Product hierarchy no. *			Part no.	SBU	Type / Description	Customer part no.
SBU	PG	PGU	Type			
02	006	016	0000001535	See list below	Power Entry Module with Filter	DC12

2 Type of change

Product Change Notification					PCN DC12		
owner	creation date	release date	released by	change order no	rev	page	0118.2320
ismaibe	2016-06-03	2016-06-03	buiho	2009810	B	1 of 2

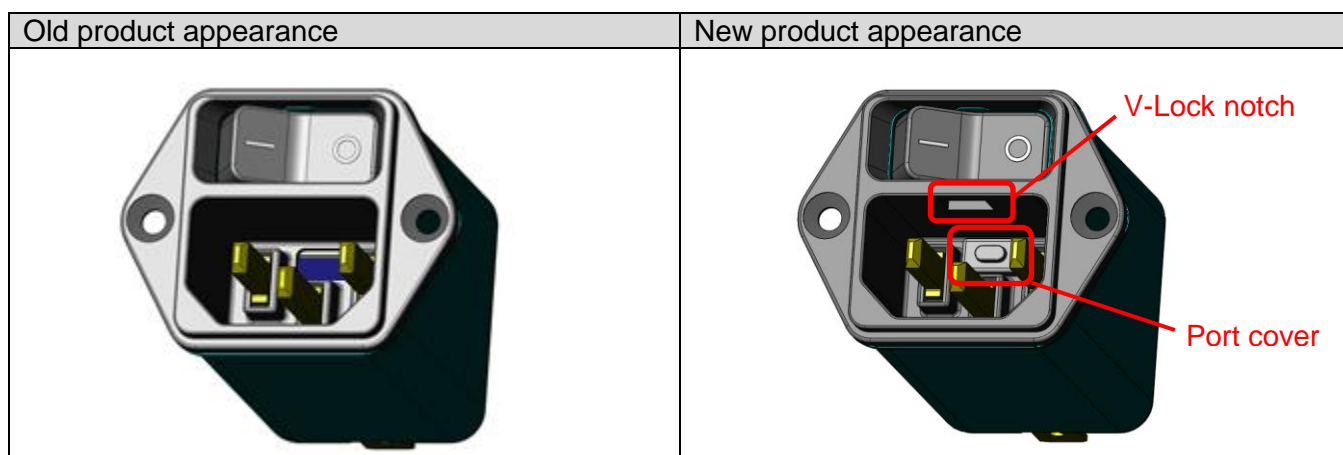
Change of material for higher GWFI/GWIT, implementation of V-Lock cord retaining feature as standard and port cover for closing potting hole.

- Material change from PA6 to PA66/6
- V-Lock feature integrated as standard (not an option anymore)
- Port cover added to close potting hole

- To pass the enhanced material requirements of glow wire acc. to IEC 60695-2-12 and -13
- V-Lock feature implemented as a standard feature
- No open potting visible

Form	Yes	Socket has notch for V-Lock cord and port cover for closing potting hole
Fit	No	There are no dimensional changes
Function	Yes	V-Lock feature is standard (not an option anymore)
Production Site	No	There is no change of the production site
Product Label	No	There is no change on the label
